# Product Change Notification

**Change Notification #:** 119194-00

**Change Title:** Power Supply Module AXX1300TCRPS,  
PCN 119194-00, Product Design,  
Power Supply Update

**Date of Publication:** July 19, 2022

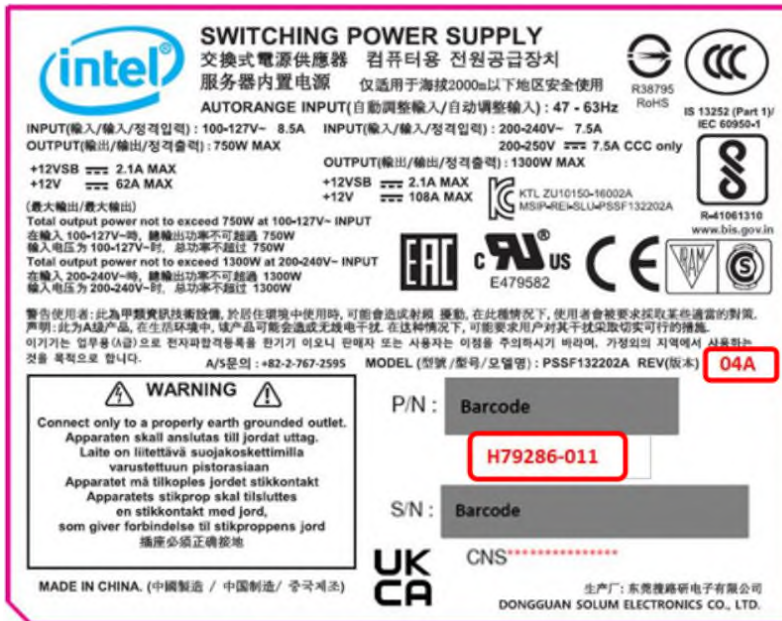
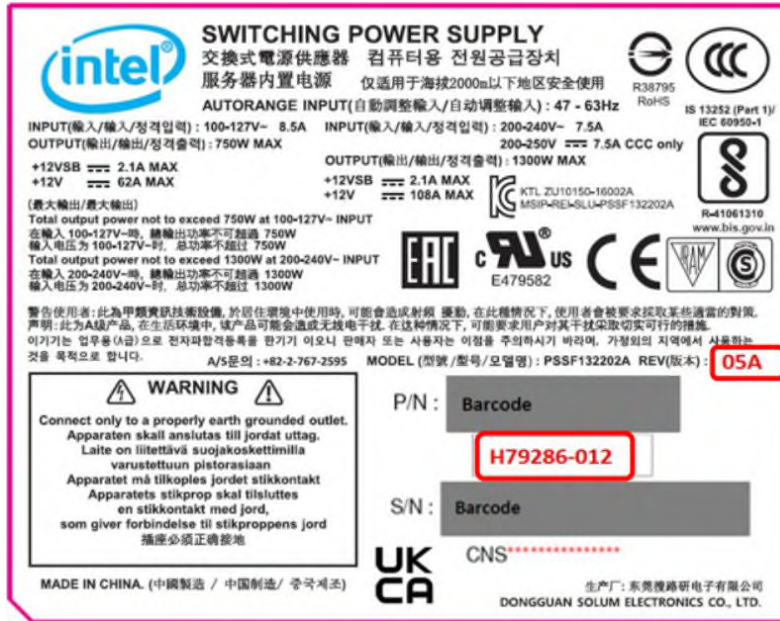
The 1300W Power supply is changing from H79286-011 to H79286-012 due to a firmware upgrade from 26.5.128 to 29.5.128 and a minor hardware change, there is no impact on functionality.
